Memorandum

To:	Rebecca Cook - Spokane Tribe of Indians
From:	Noah Hornsby - McMillen, Inc.
Date:	March 25, 2025
Subject:	Initial Responses to Pre-bid Questions

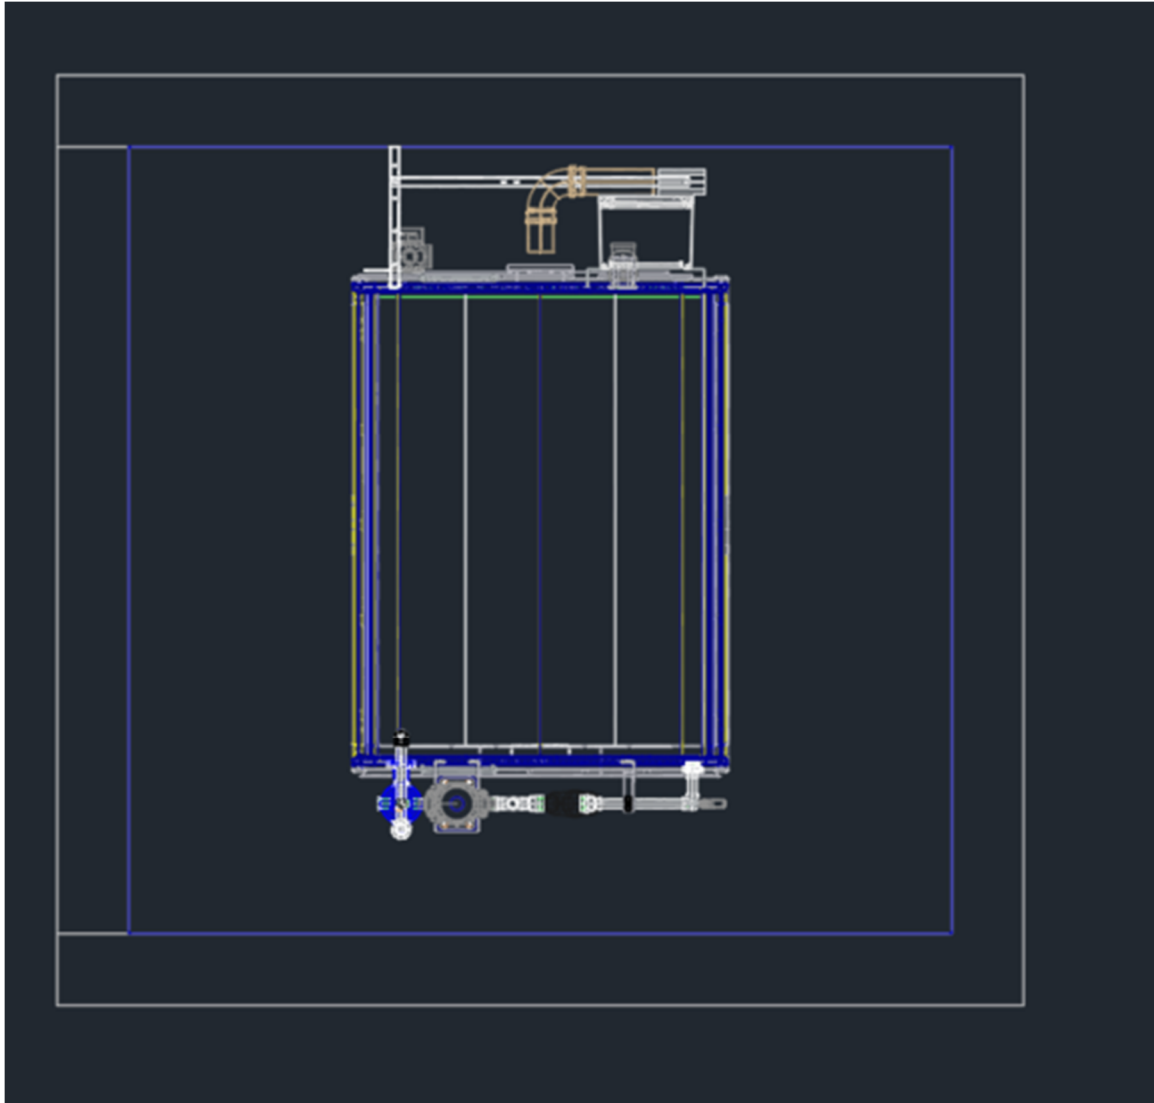
51. There is a discrepancy between the required moving bed biofilter media requirements from the missing specs and from the stamped mechanical calculations. It appears the safety factor was not included in the specs. Which volume of media will be used 934 m³ from the stamped mechanical calculations or 778.1 m³ from the equipment specs?

Assume the 934 m³ from the stamped mechanical calculations supersedes.

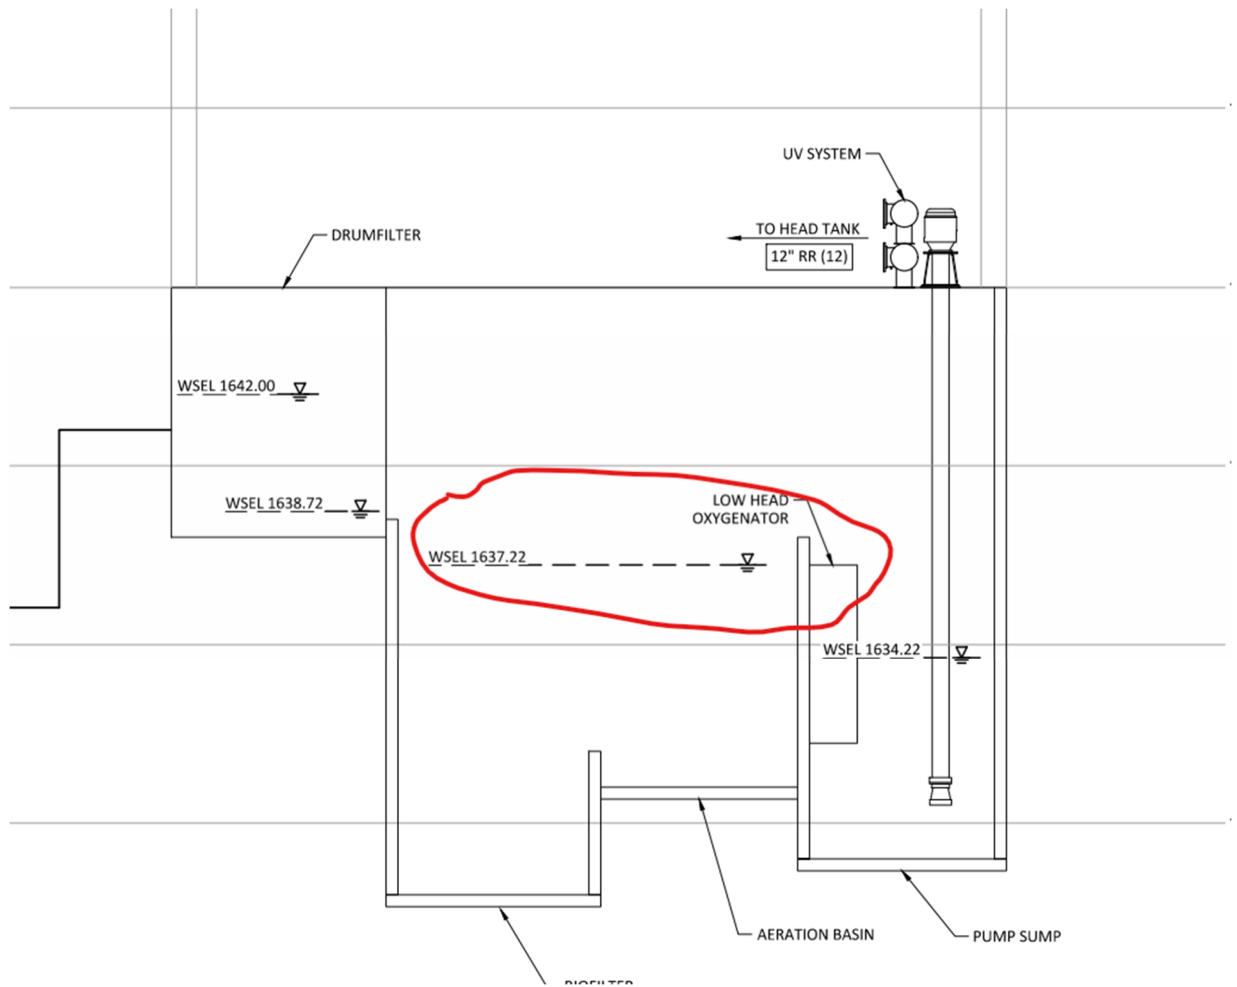
55. The water level within the aeration basin and biofilter is set at 1637.22' however the weir going into the LHO is set higher. Does the concrete divider have a window cut out to allow for the water level to be at 1637.22 or is the weir dividing the aeration basin and pump sump set at the incorrect elevation?

The weir is shown at the incorrect elevation. It should be set at elevation 1637.00. This is currently being addressed and updated IFC drawings will be issued showing the corrected weir elevation.
